Access Compliance Report

Public Rights-of-Way

(Curb Ramps)

Intersection ID: 10020356	Main Street: BALLANTYNE_COMMONS_PY	Cross Street: N/A	Location: W
ADA ID: 726238825595	Ramp Type: Directional1	Initial Pass/Fail: Fail	Overall Compliance: No
Severity Score: 1.25			
Codes/Mitigation Info/Possible Solution		Field Measurements/Component Compliance

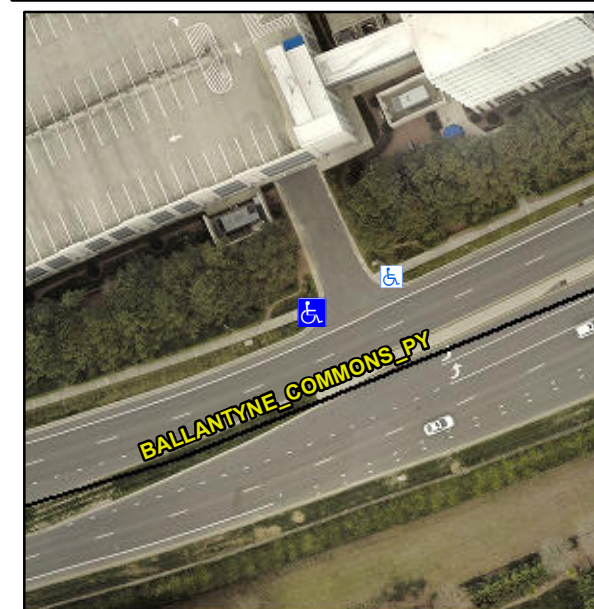
R304.5.3

Compliance	Description	Data	Compliance	Description	Data
N/A	Ramp Length (in)	102.0	N/A	Grade Break?	N/A
Yes	Ramp Width (in)	58.0	N/A	Grade Break Slope (%)	0.0
Yes	Ramp Slope (%)	7.9	N/A	Grade Break XSlope (%)	0.0
No	Ramp XSlope (%)	3.7			
N/A	Flare Type LT	N/A	N/A	Flare Type RT	N/A
N/A	Flare Slope LT (%)	N/A	N/A	Flare Slope RT (%)	0.0
N/A	Flare Traversable LT?	N/A	N/A	Flare Traversable RT?	N/A
N/A	Landing Length (in)	0.0	N/A	DWS Provided?	N/A
N/A	Landing Width (in)	0.0	N/A	DWS Contrast?	N/A
N/A	Landing Slope (%)	0.0	N/A	DWS Length (in)	N/A
N/A	Landing X Slope (%)	0.0	N/A	DWS Full Width?	N/A
N/A	Landing Curb? (Y/N)	N/A	N/A	DWS Offset LT (in)	N/A
N/A	Shared Landing?	N/A	N/A	DWS Offset RT (in)	N/A
N/A	Gutter Ponding?	0.0	N/A	Gutter Slope (%)	N/A
N/A	Gutter Lip Ht (in)	0.0	N/A	Gutter X Slope (%)	N/A
N/A	Painted X Walk1?	No		Road Slope (%)	1.9
	X Walk 1 Direction	To NE		Road X Slope (%)	3.8
	X Walk 1 Width (in)	N/A		Clear Space?	N/A

Remove & Replace Entire Ramp.
